# Access Compliance Report

## Public Rights-of-Way

Intersection ID: 27494	Main Street: BALLANTYNE COMMONS PY	Cross Street: SUMMIT COMMONS BV	Location: SW
ADA ID: 9FD24FE1FB00	Ramp Type: Perp	Initial Pass/Fail: Fail	Overall Compliance: No
			Severity Score: 21.25

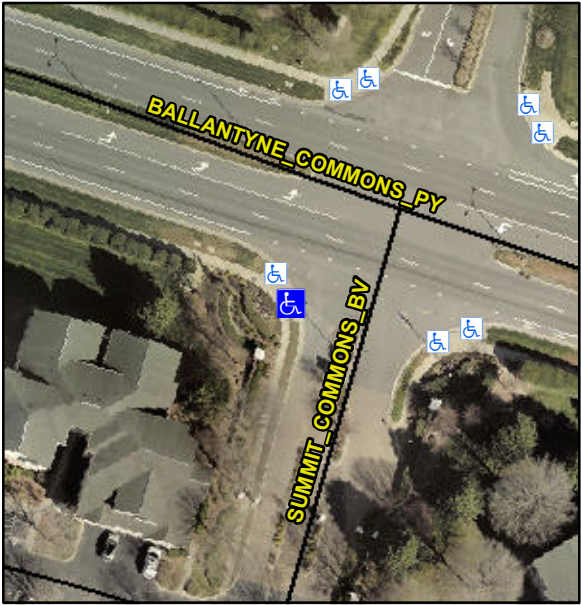
Codes/Mitigation Info/Possible Solution		Field Measurements/Component Compliance			
	Possible Solutions:				
	Remove & Replace Entire Ramp.				
	Surveyor Notes:				
	N/A				
	PROW/ADA:				
	R304.5.1, R304.5.3				
Street 1 Name	SUMMIT COMMONS BV				
Stop Condition-Street 2	StopSign				
Street 2 Name	N/A				
Stop Condition-Street 1	N/A				
Total Cost:		\$	1850.00

Compliance	Description	Data	Compliance	Description	Data
N/A	Ramp Length (in)	108.0	Yes	Ramp Slope (%)	5.3
No	Ramp Width (in)	43.0	No	Ramp XSlope (%)	5.8
N/A	Flare Type LT	N/A	N/A	Flare Type RT	N/A
N/A	Flare Slope LT (%)	N/A	N/A	Flare Slope RT (%)	N/A
N/A	Flare Traversable LT?	N/A	N/A	Flare Traversable RT?	N/A
N/A	Landing Length (in)	N/A	N/A	DWS Provided?	N/A
N/A	Landing Width (in)	N/A	N/A	DWS Contrast?	N/A
N/A	Landing Slope (%)	N/A	N/A	DWS Length (in)	N/A
N/A	Landing X Slope (%)	N/A	N/A	DWS Full Width?	N/A
N/A	Landing Curb? (Y/N)	N/A	N/A	DWS Offset (in)	N/A
N/A	Shared Landing?	N/A			
N/A	Gutter Ponding?	N/A	N/A	Gutter Slope (%)	N/A
N/A	Gutter Lip Ht (in)	N/A	N/A	Gutter X Slope (%)	N/A
N/A	Painted X Walk1?	No	N/A	Painted X Walk2?	N/A
	X Walk 1 Direction	To SE		X Walk 2 Direction	N/A
N/A	X Walk 1 Width (in)	N/A	N/A	X Walk 2 Width (in)	N/A
	X Walk 1 Slope (%)	3.9		X Walk 2 Slope (%)	N/A
	X Walk 1 X Slope (%)	2.7		X Walk 2 X Slope (%)	N/A
